Appl. No. 10/689,257  
Amdt. dated August 15, 2006  
Reply to Office Action of 15 May 2006

**Amendments to the Drawings:**

Formal drawings are submitted with this amendment. Additionally, FIG. 14A and FIG. 19E have been amended as shown by the annotated sheets marked in red to show the changes.

6/10

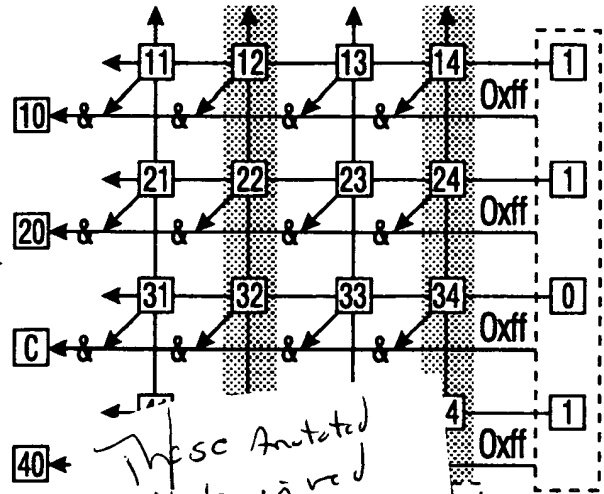
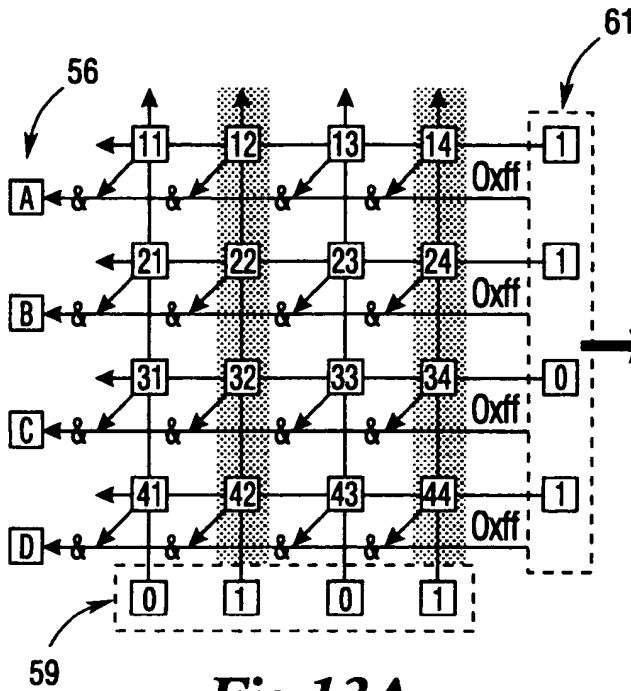
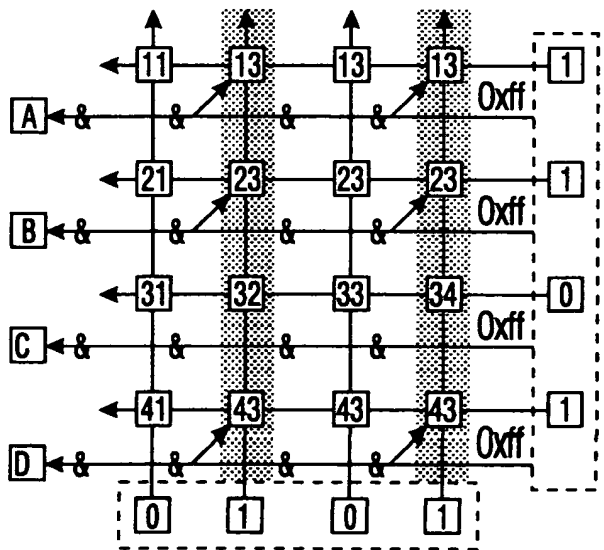
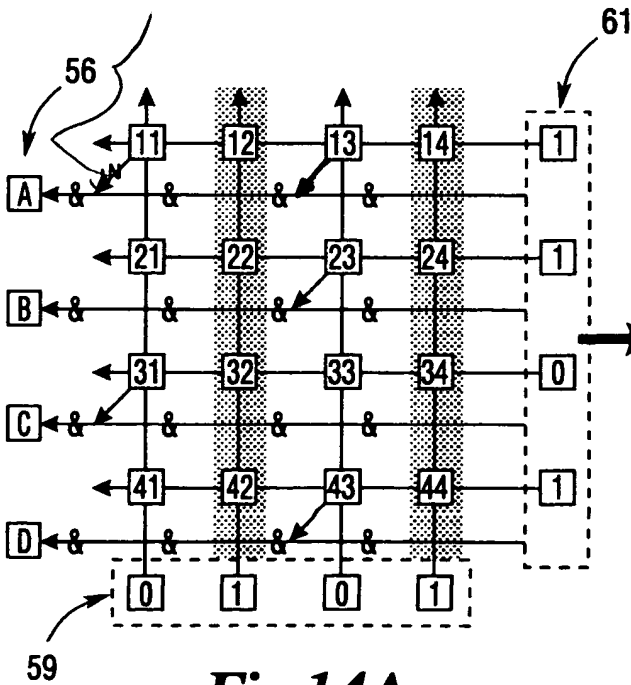
In paragraph 6 of the Office action, the examiner has objected to Fig. 14A on the basis that “it appears that there should not be a diagonal arrow emanating from element 11.” In response, the diagonal has been eliminated from element 11 and is now shown as emanating from element 13. An annotated sheet 6/10 is enclosed showing the changes in red.
